UNITED STATES PATENT AND TRADEMARK OFFICE

| APPLICATION NO. | FILING DATE | FIRST NAMED INVENTOR | ATTORNEY DOCKET NO. | CONFIRMATION NO. |
|-----------------|-------------|----------------------|---------------------|------------------|
| 09/982,584 | 10/17/2001 | Jorn von Seggern | 400004=2012 | 7560 |

Office Action Summary

Part of Fig. 4 of Greenwell '887

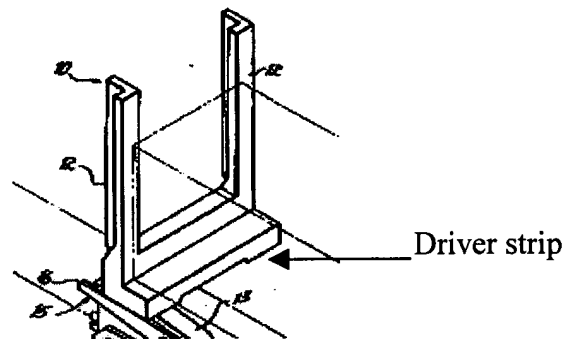
Greenwell discloses all of the claim limitations in a similar conveyor apparatus for transporting objects shown in fig. 4, the apparatus comprising a plurality of continuously circulating guided conveyor lines (20, 20a) with drivers (10,11) arranged at intervals from each other wherein the conveyor line is constructed of continuously circulating individual chains (20) each of which has respective drivers (10, 11) arranged at intervals from each other, the intervals

between the drivers of different individual chains may be adjusted (C4/L20-26) simultaneously. Greenwell further discloses that the drivers (10, 11) are held on each conveyor line (20, 20a) so that they can be adjusted in the direction of transport (C4/L23-26) and that the drivers (10, 11) connected to each conveyor line (20, 20a) are located at fixed intervals from each other (C4/L41-63).

Greenwell additionally discloses that each driver has driver strips (fig. 4) that extend across all of the conveyor lines transversely to the direction of transport.
